Consideration of the request of HHT Devco, LLC for Preliminary Site Plan Phase 3 approval for modifications to allow a new driveway entrance on Donelson Drive at the existing Twelve Mile Crossing at Fountain Walk shopping center. The property is located west of Novi Road between I-96 and Twelve Mile Road in Section 15 in the RC, Regional Center District. The plan adds an entrance from Donelson Drive, modifies the parking lot and landscaping, adds three entrance structures and provides a pedestrian connection to Donelson Drive.

# Twelve Mile Crossing at Fountain Walk

**Subject: Response Letter  
 Twelve Mile Crossing at Fountain Walk Phase III, SP# 07-12**

## PLAN REVIEW CENTER REPORT

**INTERSECTION DESIGN  
MODIFIED AFTER THE  
PLANNING COMMISSION MEETING  
TO ADDRESS CONCERNS**

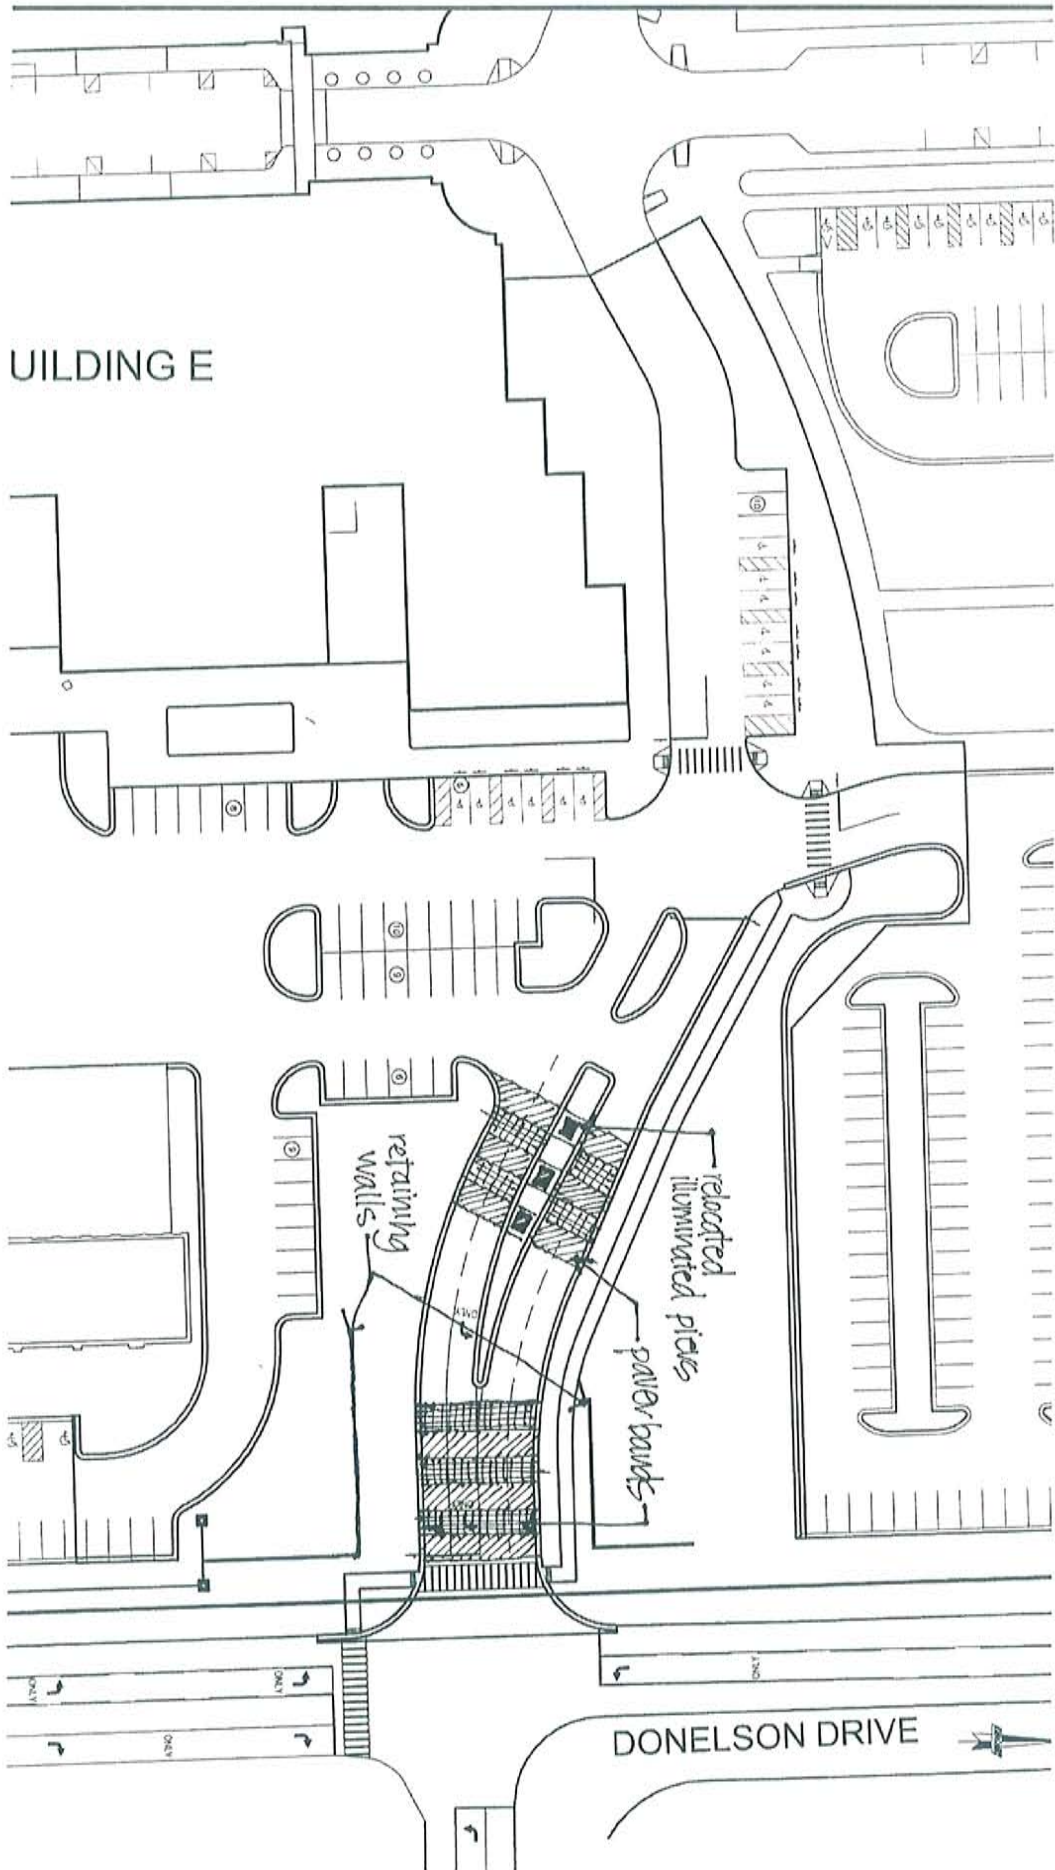
- Reconfigures the intersection to provide an additional traffic lane to facilitate left turns out of the site,
- Realigns the entrance drive lanes to reduce left turn conflicts and

- Relocates the proposed entrance drive island further west onto the site to remove the entrance structures from the required 100 foot setback.

Please see attached small version of modified entranceway design. The City's Traffic Consultant and Staff have reviewed this modified proposal and recommend approval of the changes.

INTERSECTION DESIGN  
REVIEWED BY THE  
PLANNING COMMISSION MEETING  
AND  
ASSOCIATED ILLUSTRATION

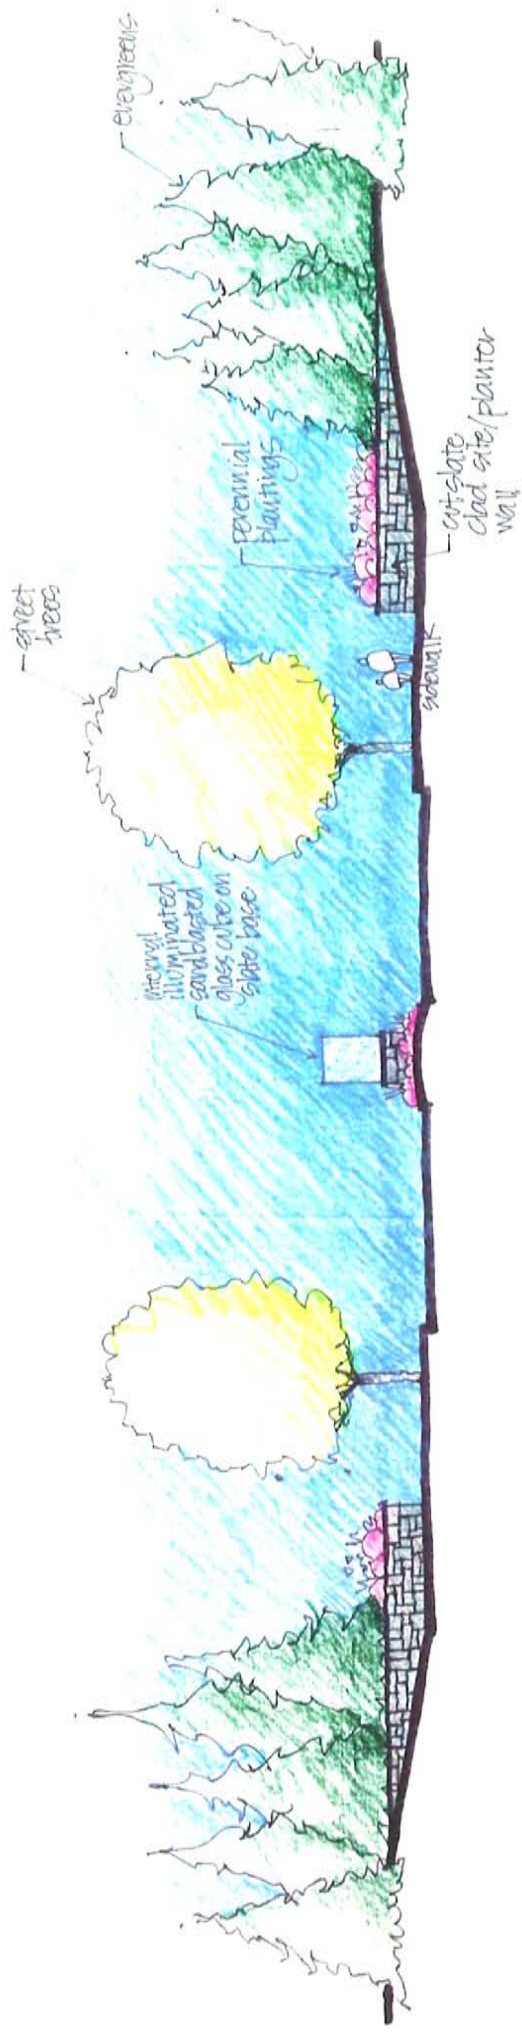
The Traffic Review asks the developer to redesign the intersection to eliminate left turn conflicts and to provide left

turns from the site. The review also asks for better pedestrian connectivity from this site to the easterly Donelson sidewalk. Mr. Spencer showed a picture of the area in question.

*Proposed Sidewalk*

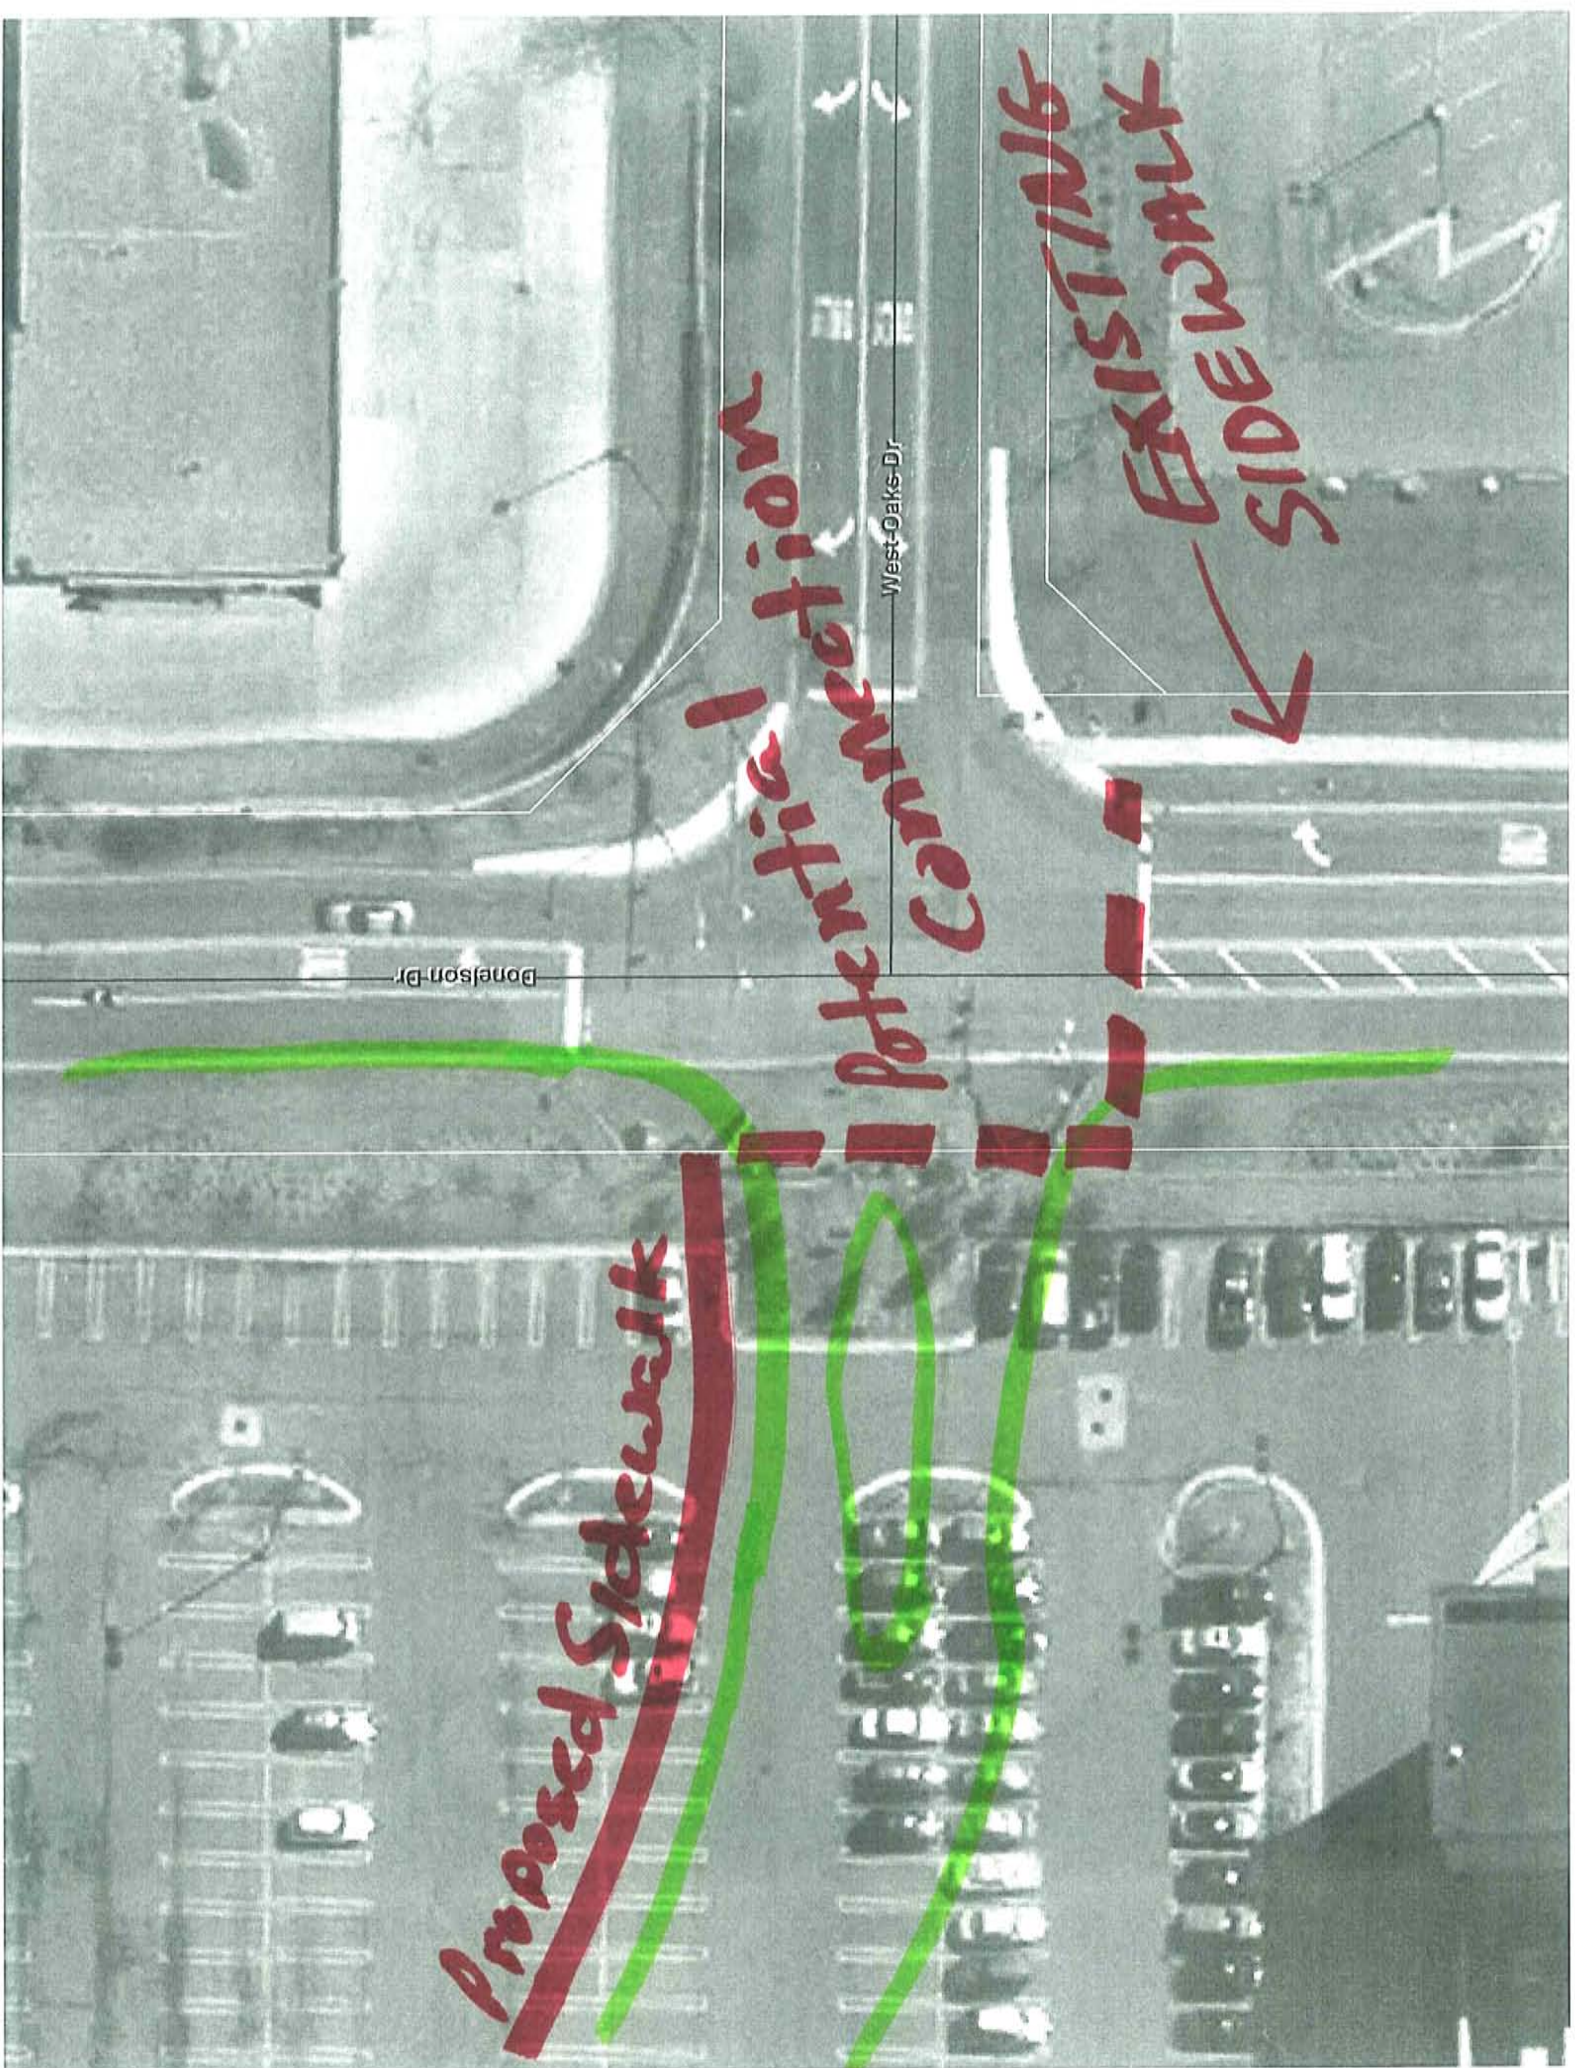
require this connection to provide safe pedestrian circulation. The applicant is asked to connect the proposed internal sidewalk with the existing sidewalk located at the southeast corner of the intersection including appropriate crosswalks, sidewalk ramps and pedestrian crossing signals (see attached sketch).

2. Sidewalk: as mentioned above, the installation of a new sidewalk along the west side of Donelson Drive at this time would require the removal of a significant amount of mature landscape material. We therefore request a waiver of this requirement at this time, and will work with the City staff during subsequent phases to provide pedestrian connectivity to Twelve Mile Road. We also concur that the proposed internal sidewalk (located north of the proposed drive approach) should connect to the existing sidewalk network adjacent to the site and will modify our plans to provide this connection.

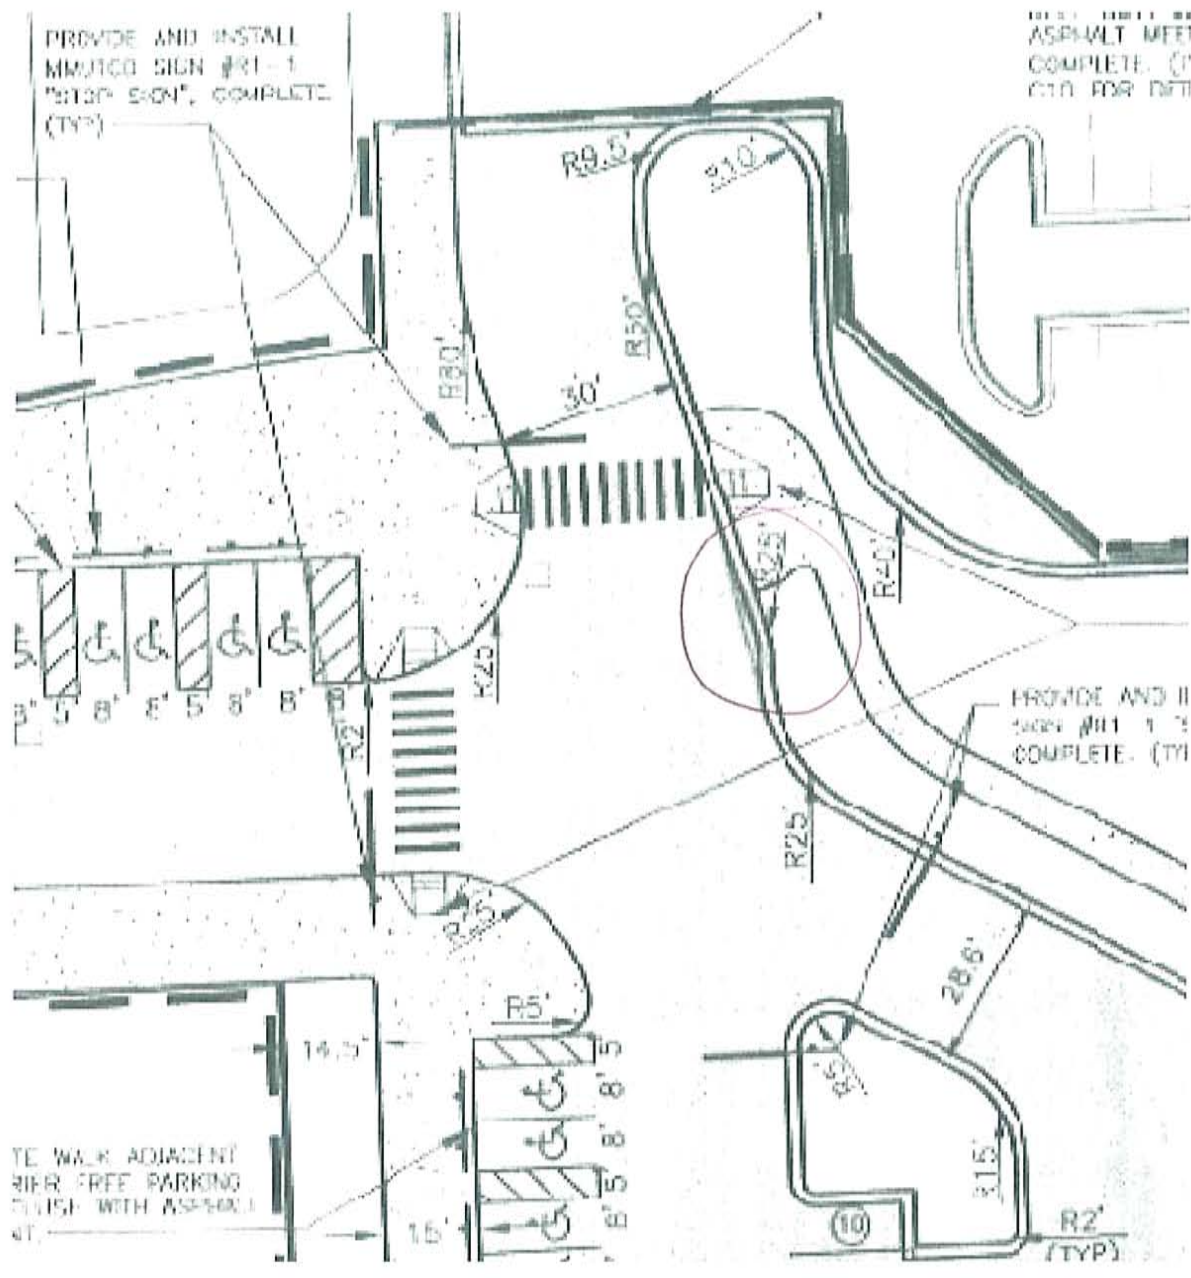
If the developer wishes to retain the boulevard entrance, significant changes to the geometry of the median island are required. In order to provide a properly aligned left turn lane, the nose of the island should be pulled back, and a gradual taper should be created to provide adequate storage for left-turning vehicles. The island should be extended to the west, and there should still be only one inbound lane. Please see the attached sketch.

4. Circulation Aisle: There is a taper on the east side of the north/south circulation aisle, kiddy-corner from Building E. The curbline should be modified to create a gradual taper along the entire length, as shown in the attached sketch.

1. Intersection Design: we have already spoken with Mr. Steve Dearing of OHM to discuss options related to the proposed drive approach geometry. We have eliminated the proposed boulevard at the end of the drive approach to allow for the proper alignment of lanes with West Oaks Drive. We have further provided a left turn lane out of the site, allowing for 100 feet of vehicle storage, in accordance with Mr. Dearing's request. During our conversations Mr. Dearing agreed to allow two lanes to enter the site, and as such as have maintained this configuration. We do note on the plans that we will be upgrading the existing traffic signal at this intersection and will work with the City and the Road Commission for permit approval.

4. Circulation Aisle: we will adjust the curb line as suggested.
5. Traffic Signs: traffic sign quantities will be identified on the plans.
6. Parking: as mentioned in the planning section of your review letter, we are proposing to relocate 13 of the 15 existing barrier free parking spaces to provide more direct access to the buildings. A revised parking calculation will be provided, as mentioned above.
